SUBJECT: SUBMITTAL OF DRAFT STANDARD SAFETY ANALYSIS REPORT MARKUPS  
PERTAINING TO CHAPTERS 9, 10, AND 11

Attached are Westinghouse draft-markups of the AP600 standard safety analysis report (SSAR) provided to the staff via Federal Express and facsimile. The SSAR section and submittal information are provided below. These markups were discussed in telephone conferences and were sent to the staff to facilitate resolution of open items in the Plant Systems Branch review areas.

Attachment: Draft markups from  
SSAR Chapters 9,  
10, and 11

AP600 - LIQUID RADWASTE SYSTEM

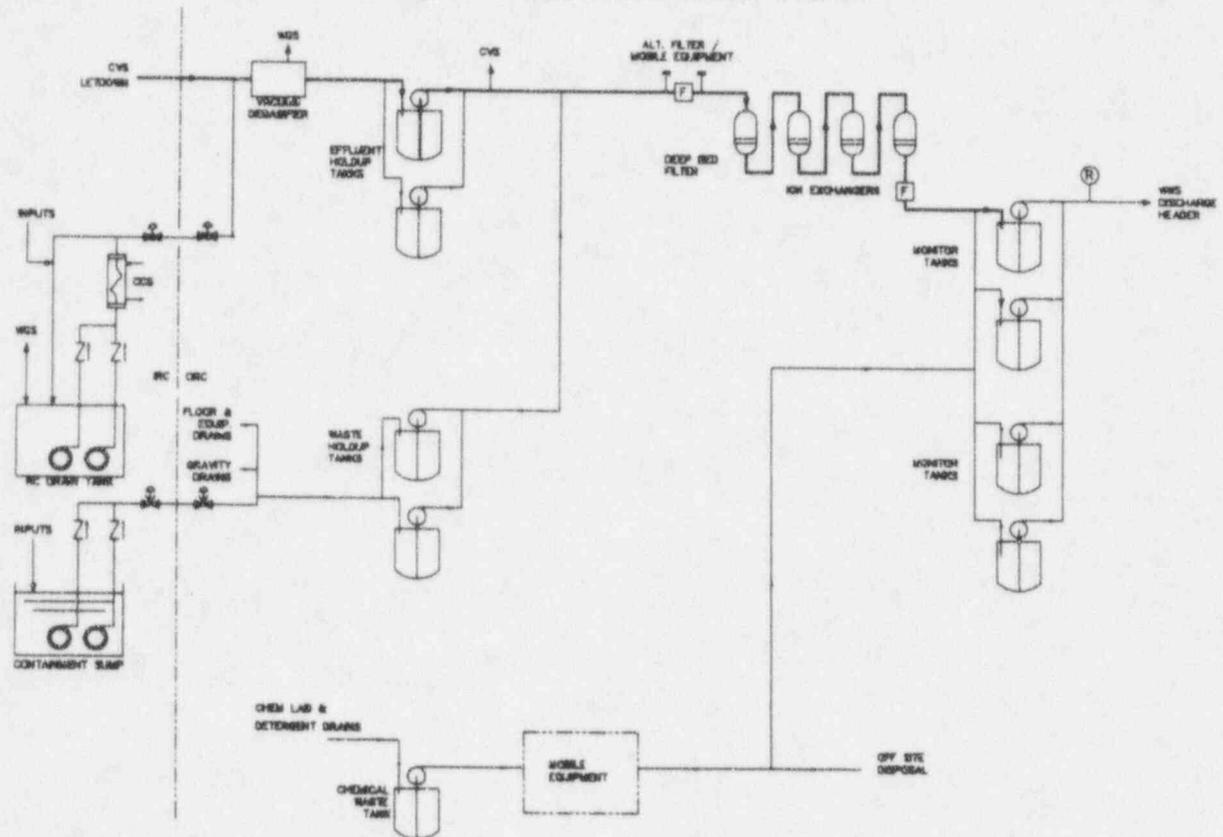
1 (Following figure is revised)

Add  
6  
sheet P + ID
